#### **Addendum 47 – UN Regulation No. 48**

#### **Revision 6 - Amendment 14**

Supplement 8 to the 03 series of amendments – Date of entry into force: 4 January 2023

#### **Uniform provisions concerning the approval of vehicles with regard to the installation of lighting and light-signalling devices**

## "Annex 4

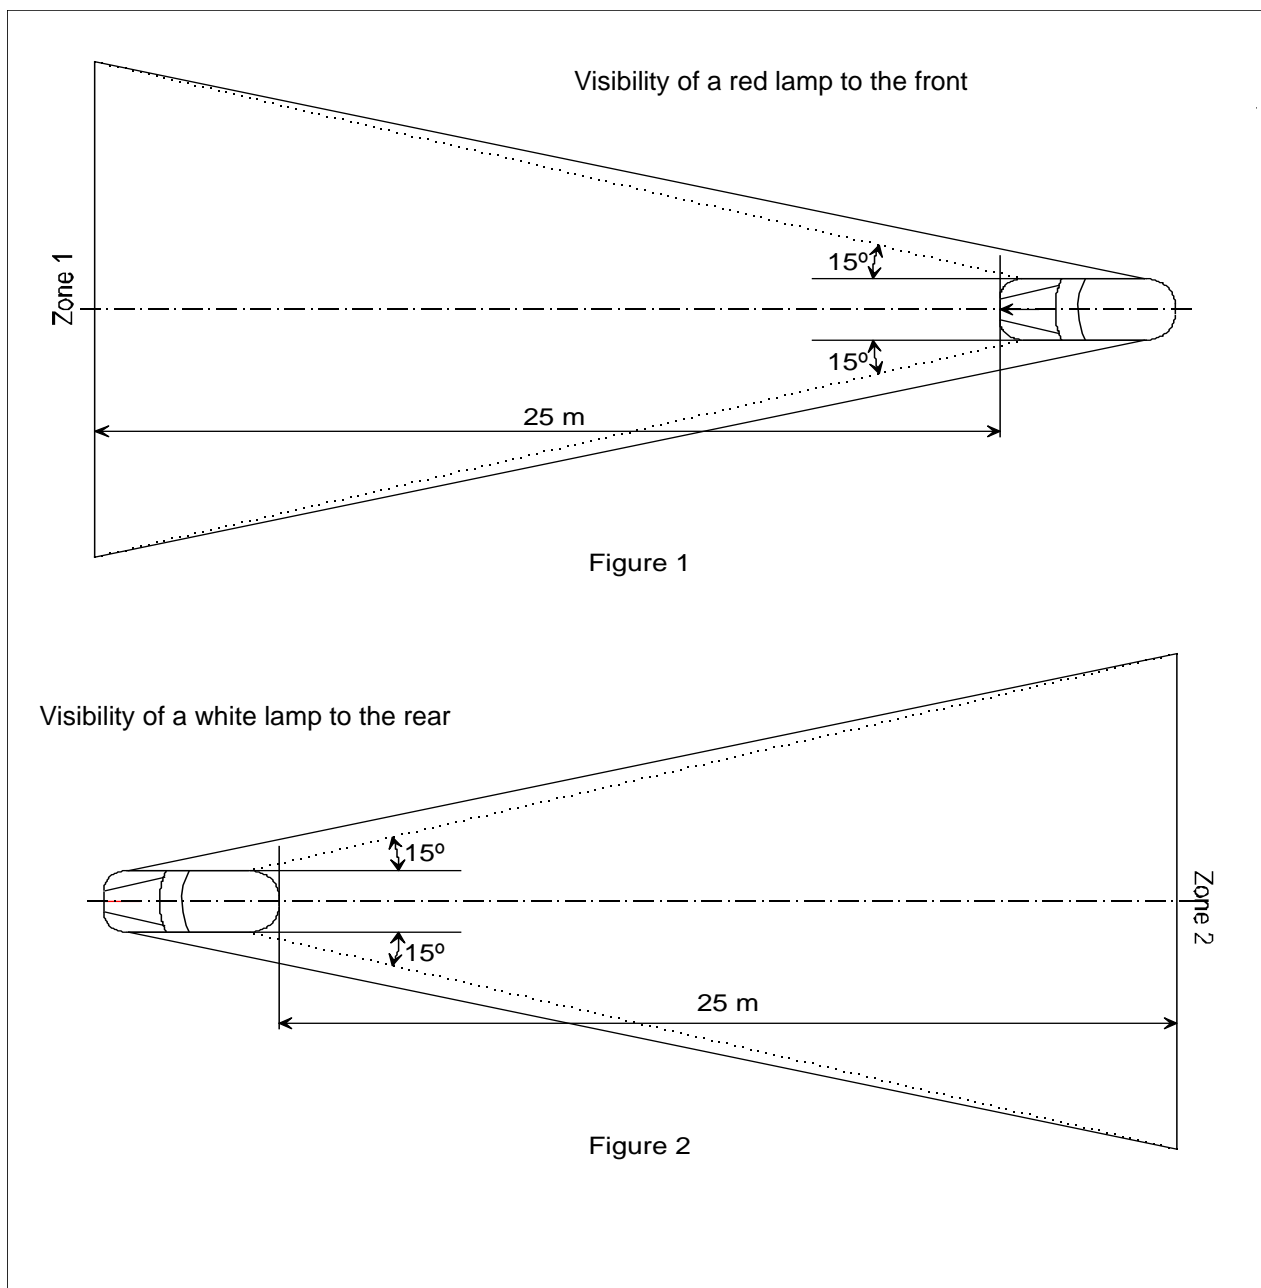
Annex 4, amend to read:

### Visibility of a red lamp to the front and visibility of a white lamp to the rear

(See paragraph 5.10.4. of this Regulation)

In their respective planes, the zones 1 and 2 explored by the eye of the observer are bounded:

- In height, by two horizontal planes 1 m and 2.2 m respectively above the ground;
- In width, by two vertical planes which, forming to the front and to the rear respectively an angle of 15° outwards from the vehicle's median longitudinal plane, pass through the point or points of contact of vertical planes parallel to the vehicle's median longitudinal plane

delimiting the vehicle's overall width; if there are several points of contact, the foremost shall correspond to the forward plane and the rearmost to the rearward plane."
